PROPOSED RESIDENTIAL DEVELOPMENT, LAND AT STONEY LANE, WHISTON – RESPONSE TO ACTIVE TRAVEL ENGLAND – MAY 2026

- 1 Eddisons have been instructed by Taylor Wimpey to advise on the traffic and transport issues relating to a planning application for the former Glen Dimplex Site in Whiston. (Planning Ref: 25/00672/FUL).
- 2 This Transport Note has been produced in response to the consultation response received from Active Travel England (ATE) dated 2nd March 2026.

DRAWING TITLE:
**PROPOSED UNCONTROLLED
CROSSING PLAN**

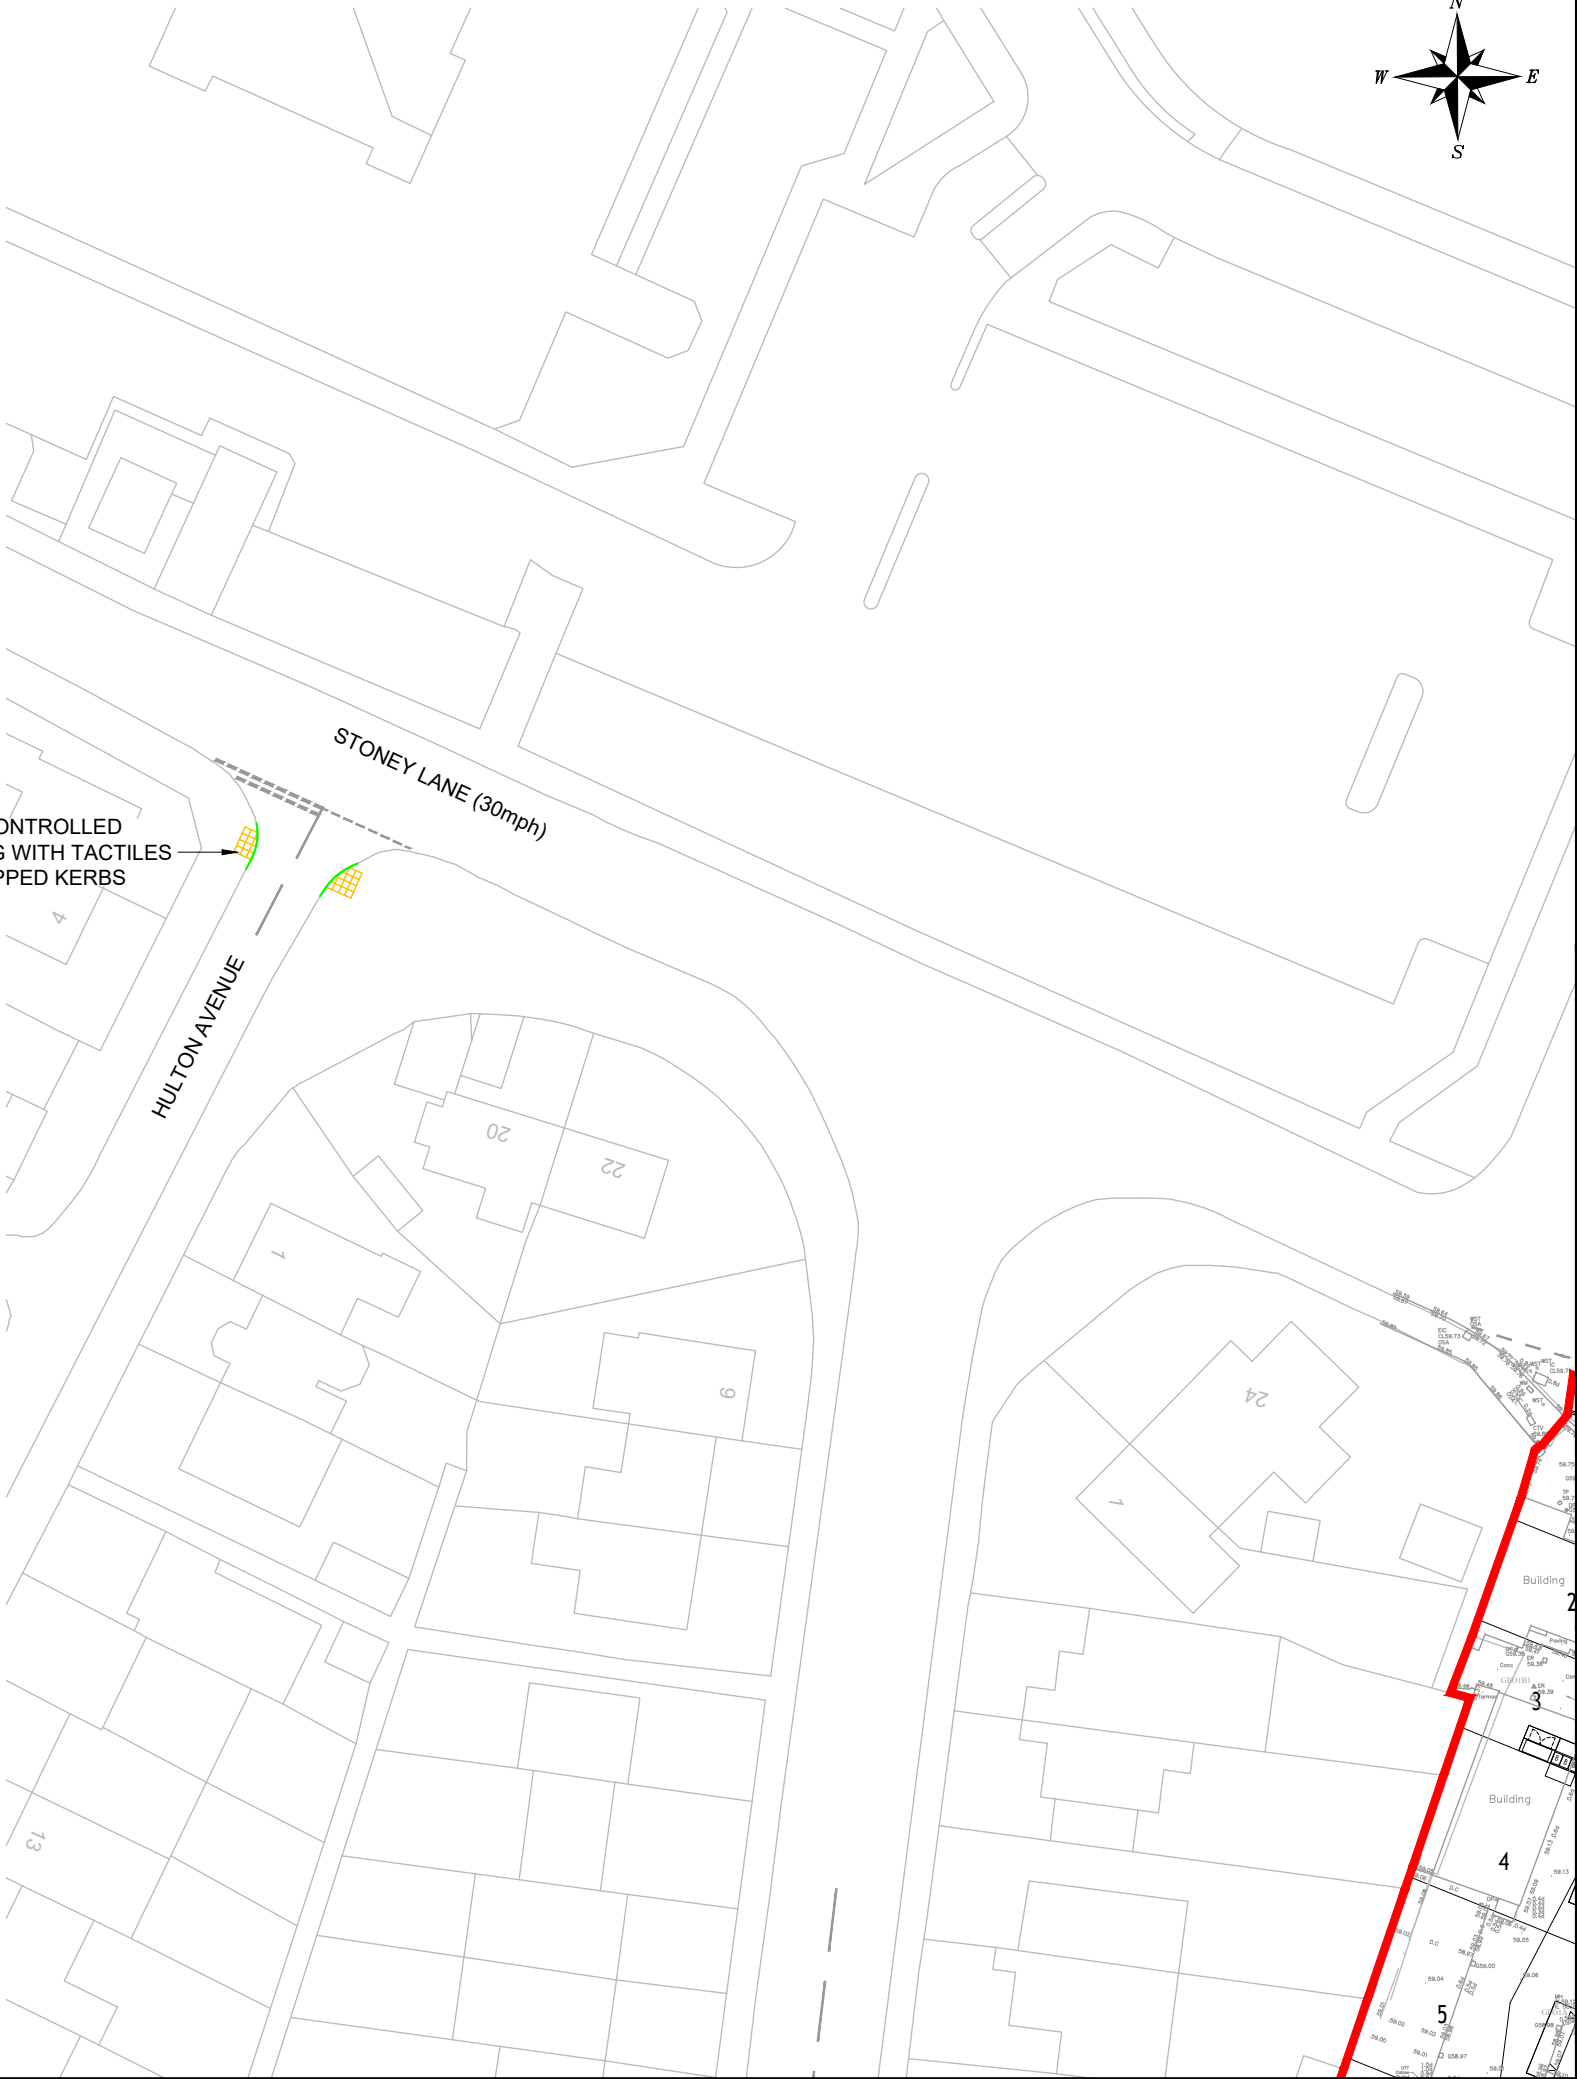
- 8 ATE has stated:
“ATE requests that the applicant clearly provides with technical drawings and images precise details of all active travel and associated infrastructure externally, including those

already proposed for the site access including the four indicative active travel only access points (DAS, p.17).

ATE also recommends that an extended active travel route audit that is experientially based with photographic evidence also takes place – this can inform the necessary improvements needed between the site and any other current and emerging active travel routes such as the various strategic active travel routes that are detailed in the recently adopted KMBC Local Cycling and Walking Infrastructure Plan (LCWIP). This is in particular reference to those that connect the proposed development to routes involving Stoney Lane and the Halsnead Village development to the south which then connect further to the East of Halewood development.”

- 9 Walking route audits to local destinations such as Whiston, Rainhill and Prescot have been undertaken. The audits assess the attractiveness, comfort, directness, safety and coherence, and identifies the potential improvements along the routes. Walking route plans have also been produced, including images of locations that could potentially be improved.
- 10 The walking route audits identified the potential improvements such as an uncontrolled pedestrian crossing with tactile paving and associated tactile paving across the Stoney Lane/Hulton Avenue priority junction.
- 11 The estimated costs for the improvement scheme at the Stoney Lane/Hulton Avenue priority junction would be between £10,000 and £15,000.
- 12 The walking route audit and associated walking route plans are provided in **Appendix 1**, whilst the proposed uncontrolled crossing plan is shown on **Plan 1**.

NEW UNCONTROLLED
CROSSING WITH TACTILES
AND DROPPED KERBS

Route 1
Proposed Site to Whiston Town Centre

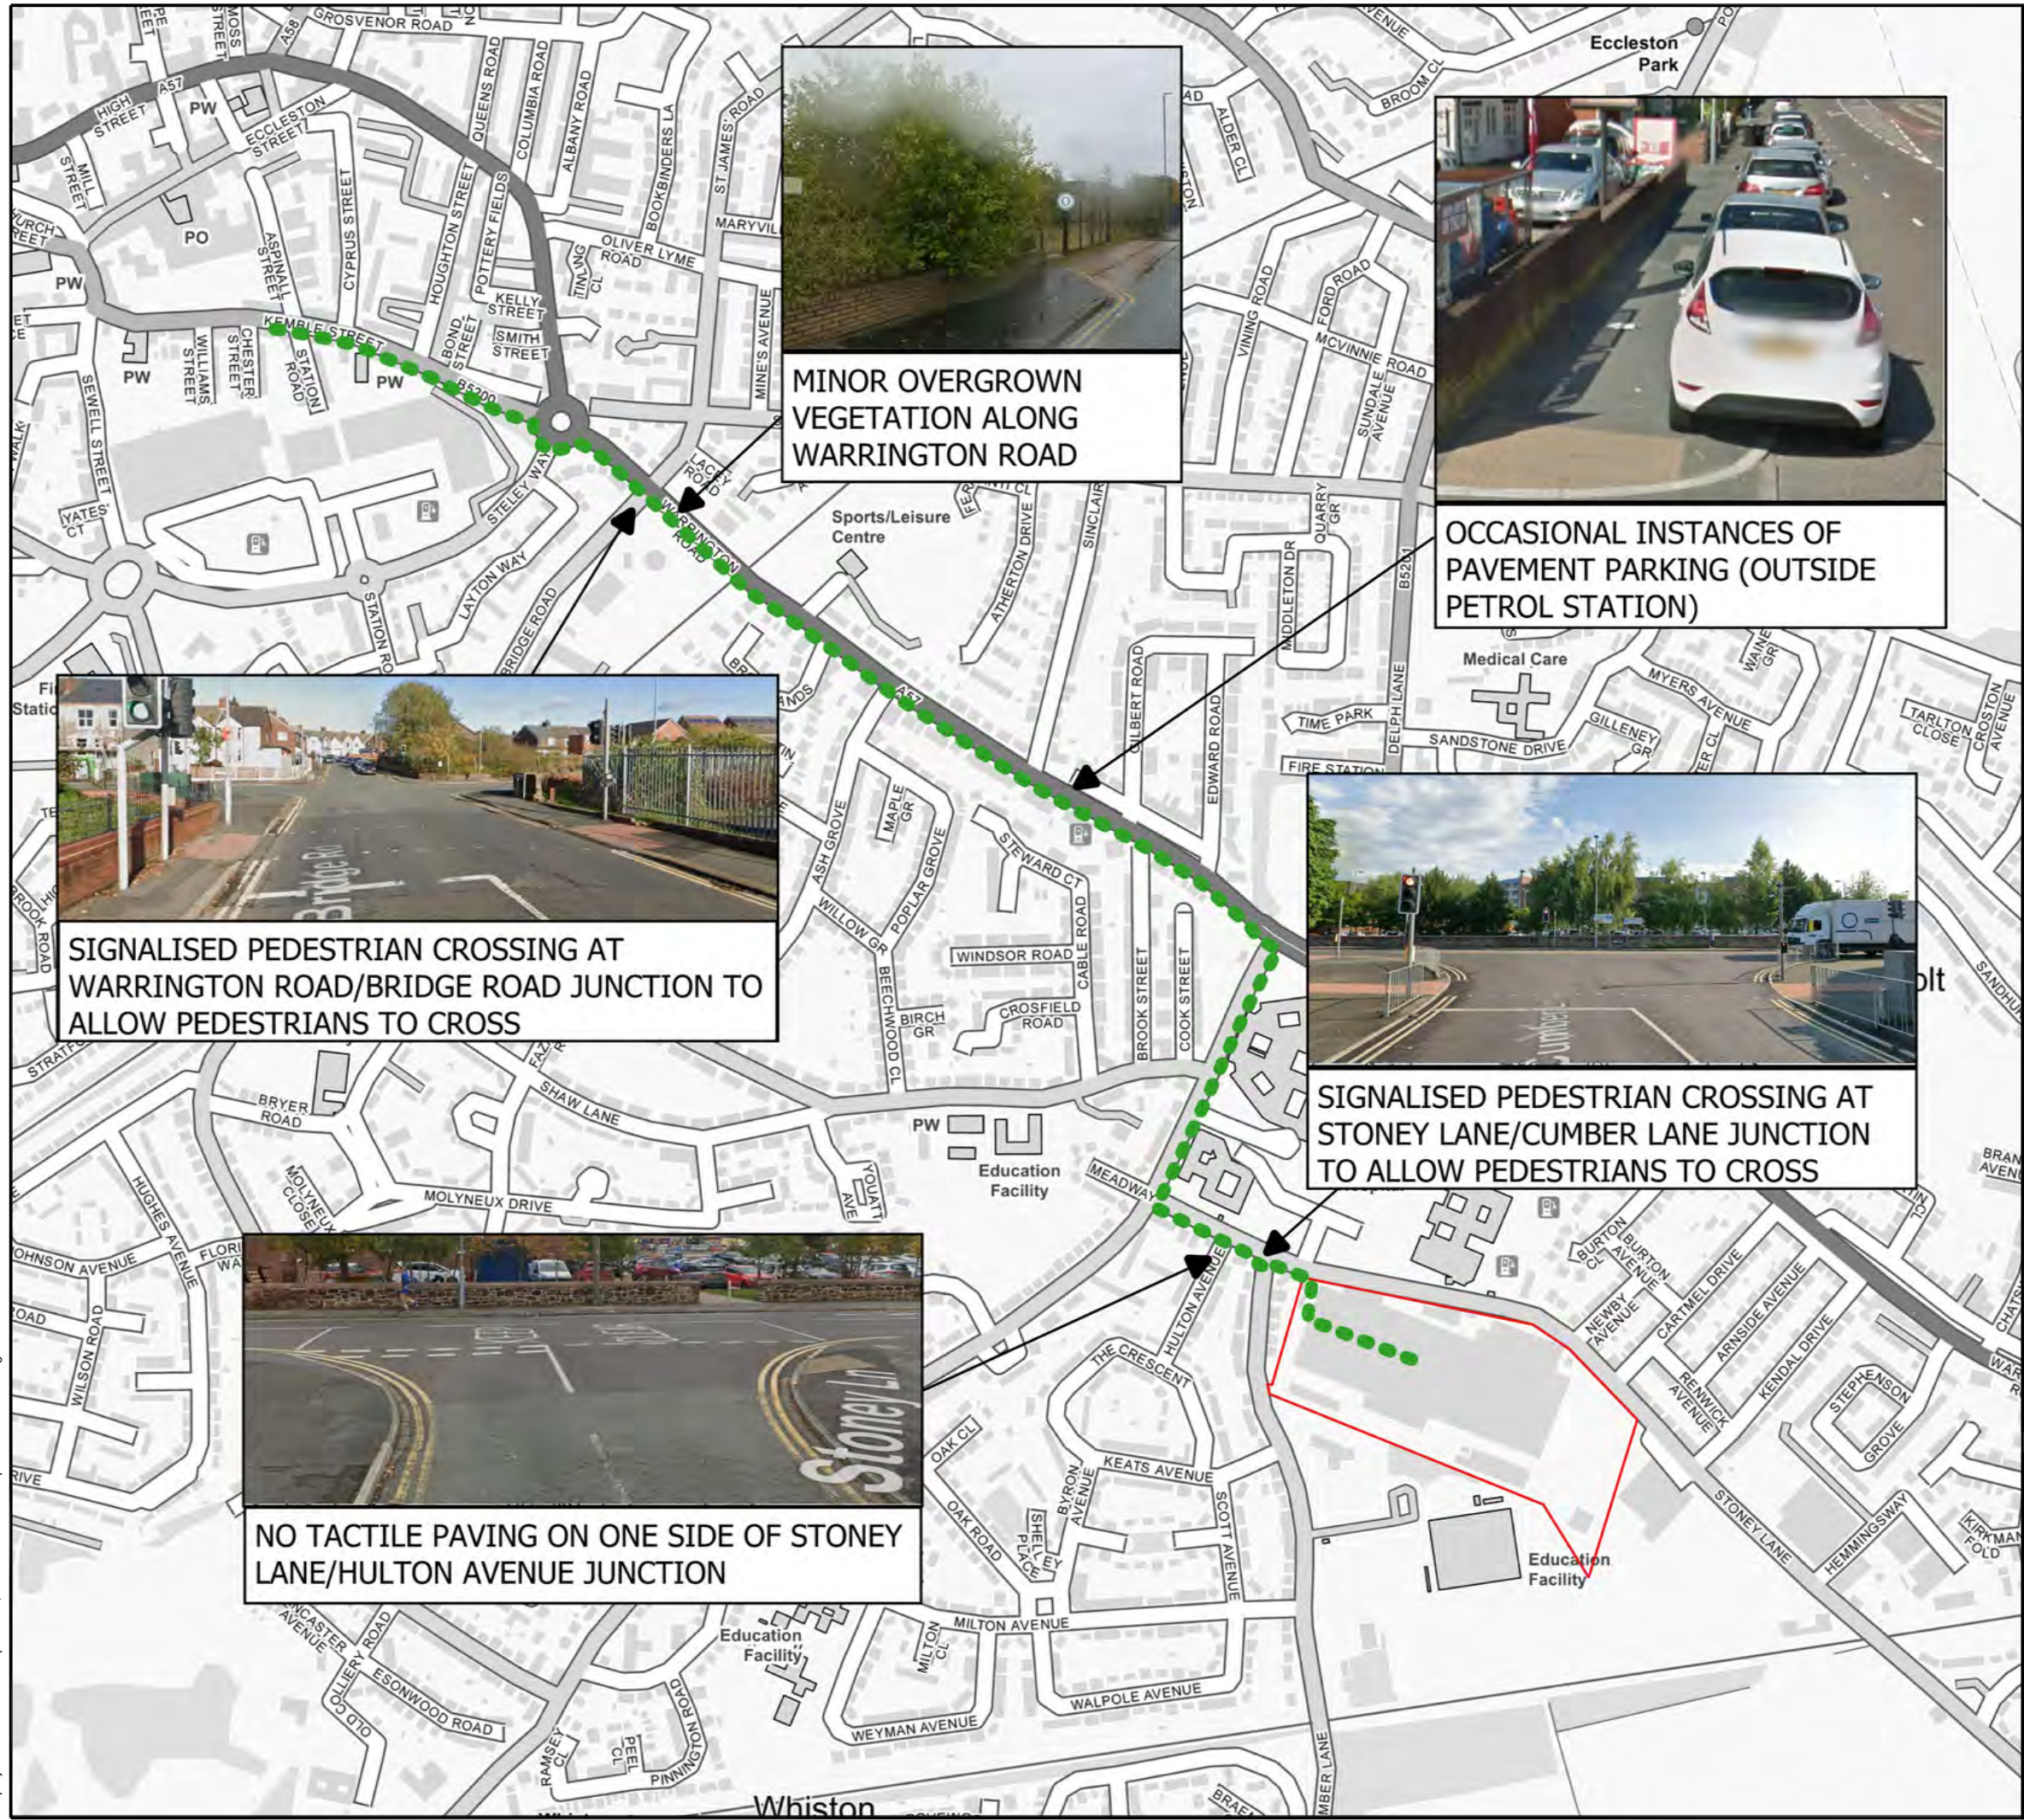
20. COHERENCE - dropped kerbs and tactile paving	Adequate dropped kerb and tactile paving provision.	Dropped kerbs and tactile paving provided, albeit not to current standards.	Dropped kerbs and tactile paving absent or incorrect.	1	Dropped kerbs and tactile paving are provided at most key crossing points. Some minor junctions are missing tactile paving.	Additional tactile paving could be provided at more minor junctions on route. Potential proportionate improvements can be discussed with the Council as the

Comments	Tactile paving could be improved at some minor - low trafficked roads along the route, however, these are not considered critical as the route is considered of a sufficient quality to encourage sustainable travel to and from the site
Actions	Potential off-site improvements are to be discussed with the Council Highways at a later stage of the planning application.
